STAFF RECOMMENDATION

NCPC File No. 6903

FORT BELVOIR
BRAC 133 PROJECT, MARK CENTER DEVELOPMENT
(WASHINGTON HEADQUARTERS SERVICES)

January 29, 2009

TRAFFIC FLOW ANALYSIS OF SLIP RAMP LOCATION BY APPLICANT

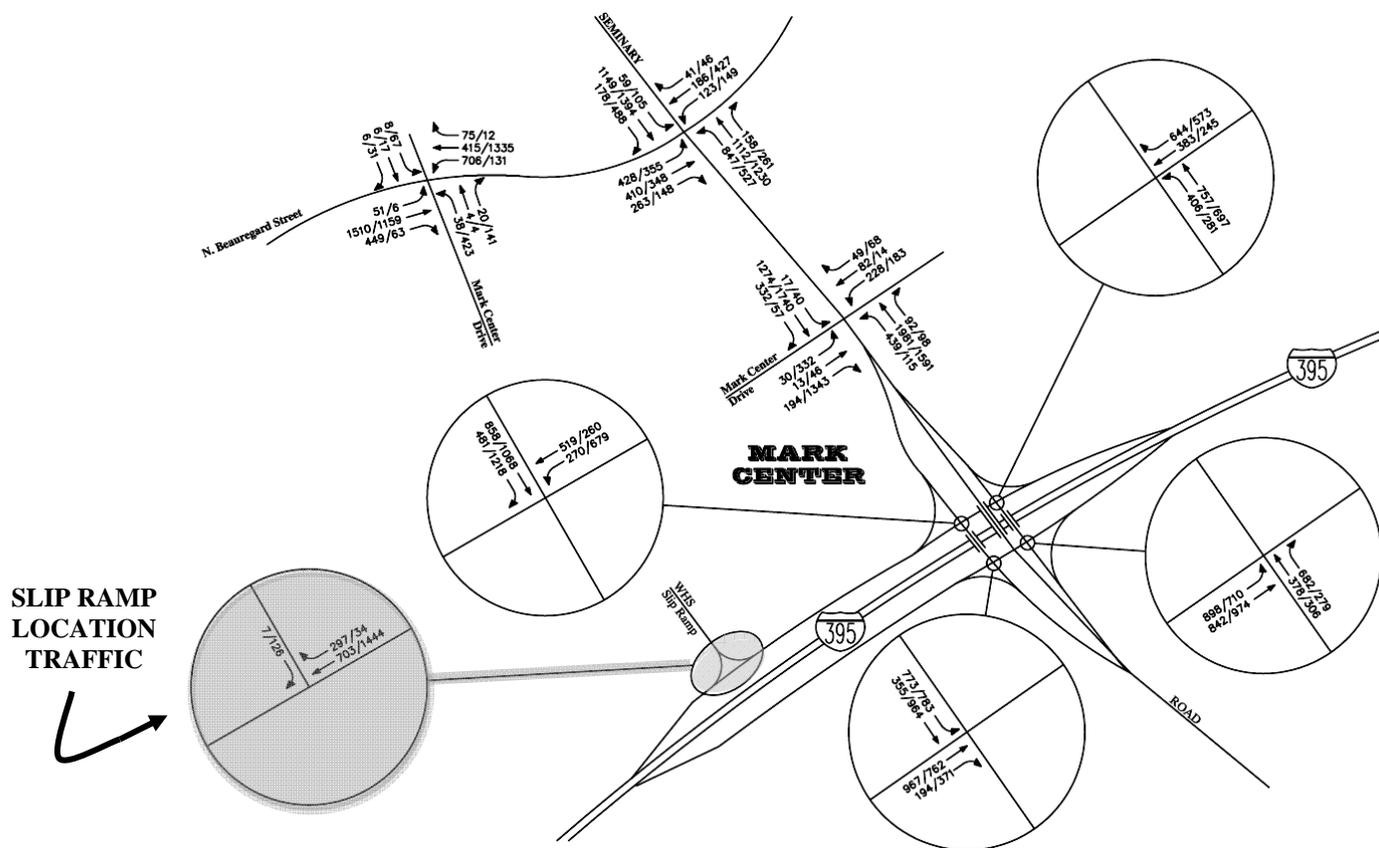
Additionally, in further implementation of the concept design the Army has agreed to the City's request to possibly put into service a slip-ramp from the South Parking garage directly connecting to I-395 southbound. One goal of the ramp modification is to reduce the number of vehicles that would travel along Seminary and North Beauregard to enter and exit the WHS by providing direct access to I-395. Access to WHS from the slip ramp to the garage would be limited to the only employee vehicles authorized to enter the BRAC 133 site. Visitor and delivery vehicles would not be allowed to use this access point, but would be required to use the entry at the Visitor's Center on Mark Center Drive and the access road leading to the Remote Inspection Facility (RIF).

Discussions in late 2008 with the Pentagon Force Protection Agency (PFPA) indicate that the concept of a slip-ramp should be feasible. PFPA will continue to assess the concept and make a formal determination. If the determination is positive, the Virginia Department of Transportation, at the Army's request, will begin preparing an Interchange Justification Report to request the modification to the south bound ramp from Seminary Road to I-395. In addition, the Army will work on a proposal to request the slip-ramp be qualified for Defense Access Road (DAR) funding.

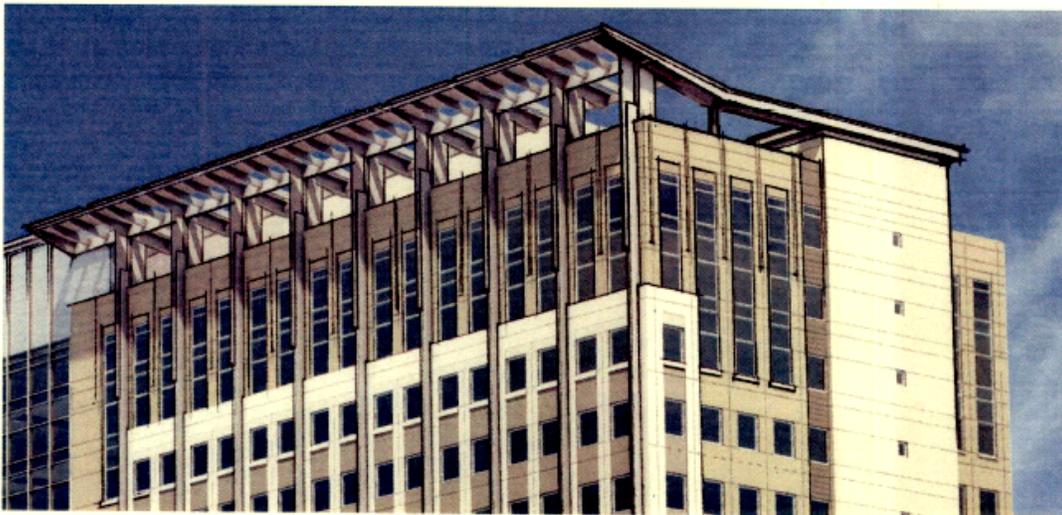
The two building drawings in this letter reflect new drawings by the applicant's architect after receiving City comments, and as a result, have begun to reflect City staff design comments and concerns.

We recommend the use of additional glass (some of which will not be vision glass because of the blast protection requirements) to reduce the perceived size of the building, provide additional visual variety and provide a more clearly defined base, middle and top to the building. We also recommend the use of contrasting darker and lighter colors of architectural precast panels to enhance vertical expression and multiple rhythms.

One of the design challenges inherent in the proposal is the required blast resistant facade. This initially resulted in a predominantly solid faced expression with square windows, making the building appear larger and the windows smaller than required by the City's design guidelines. The smaller windows were atypical of most office buildings and made the building appear more monolithic. In response to the City's comments the windows in the revised design were enlarged for the entire building and darker spandrel panels were added, resulting in an overall less monolithic expression.

As a way to better define the top of the building and to balance the solid to void ratio, the applicant has agreed to introduce a three story glass expression around the top of the building. The added glass feature creates a clearly defined frieze band and top expression and reduces the perceived mass of the building.
